Access Compliance Report

Public Rights-of-Way

Intersection ID: 50705	Main Street: HARMONIOUS_ST	Cross Street: GENERATIONS_ST	Location: NW
ADA ID: D36E06E78448	Ramp Type: PerpDiag	Initial Pass/Fail: Fail	Overall Compliance: No
		Severity Score: 37.5

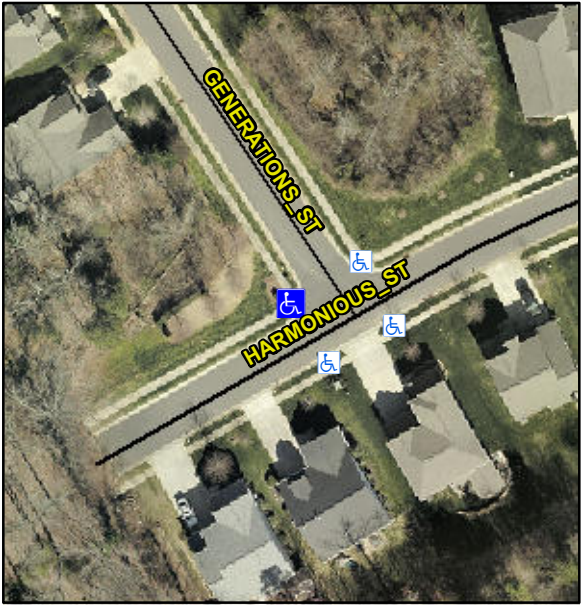
Codes/Mitigation Info/Possible Solution			Field Measurements/Component Compliance		
	Possible Solutions:		Compliance	Description	Data
	Remove & Replace Curb Ramp With Two New Directional Ramps or Equivalent.		No	Ramp Length (in)	49.0
			Yes	Ramp Width (in)	48.0
			N/A	Flare Type LT	N/A
			N/A	Flare Slope LT (%)	N/A
			N/A	Flare Traversable LT?	N/A
			N/A	Landing Length (in)	N/A
			N/A	Landing Width (in)	N/A
			N/A	Landing Slope (%)	N/A
			N/A	Landing X Slope (%)	N/A
<p>Surveyor Notes:</p> <p>N/A</p> <p>PROW/ADA:</p> <p>R304.2.2, R304.5.3</p>			N/A	Flare Type RT	N/A
			N/A	Flare Slope RT (%)	N/A
			N/A	Flare Traversable RT?	N/A
			N/A	DWS Provided?	N/A
			N/A	DWS Contrast?	N/A
			N/A	DWS Length (in)	N/A
			N/A	DWS Full Width?	N/A
			N/A	DWS Offset (in)	N/A
			N/A	Gutter Ponding?	N/A
			N/A	Gutter Lip Ht (in)	N/A
<p>Total Cost:</p> <p>\$ 3200.00</p>			No	Painted X Walk2?	No
			N/A	X Walk 1 Direction	To SE
			N/A	X Walk 1 Width (in)	N/A

N/A	X Walk 1 Slope (%)	7.4
			N/A	X Walk 1 X Slope (%)	4.2
			N/A	Ramp inside XWalk1?	N/A
			N/A	Road Slope (%)	9.6
			N/A	Road X Slope (%)	7.4
			N/A	Any Obstructions?	N/A
			N/A	Obstruction Type	N/A
			N/A	X Walk 2 Direction	To NE
			N/A	X Walk 2 Width (in)	N/A
			N/A	X Walk 2 Slope (%)	0.9
			N/A	X Walk 2 X Slope (%)	5.1
			N/A	Ramp inside XWalk2?	N/A
			N/A	Clear Space?	N/A
			N/A	Clear Space to XWalk (in)	N/A
			N/A	Storm Grate/Utility Hazard?	N/A
			N/A	Storm Grate/Utility Type	N/A
			N/A	Surface Condition? (G/P)	Good
